From: jeffrey.andrews@des.nh.gov
To: [DeMeo, Sharon M.](#)
Cc: stergios.spanos@des.nh.gov; [Cobb, Michael](#); [Nagle, John](#)
Subject: RE: Schiller Station Draft Permit
Date: Tuesday, August 18, 2015 12:43:49 PM
Attachments: [Schiller_DraftPermit \(2\).docx](#)
[Ltr to Andrews-Comments Schiller Station Permit.docx](#)
[Schiller_DraftPermit-AR.docx](#)
[Schiller_FS_NH_7_31-15-AR.docx](#)

Hi Sharon, et al, nice job on the permit and fact sheet for Schiller!

Table 8-D: Estimated Annual Macrocrustacean Impingement Abundance from Schiller Station

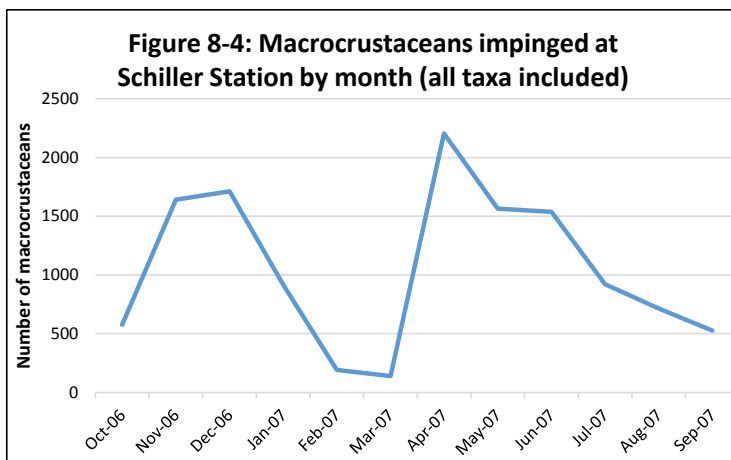
15. Page 84, Table 8-D. The bottom label "Total Entrainment" should say "Total Impingement."
16. Page 101, top paragraph, 5th line up from bottom. Delete the second "the."
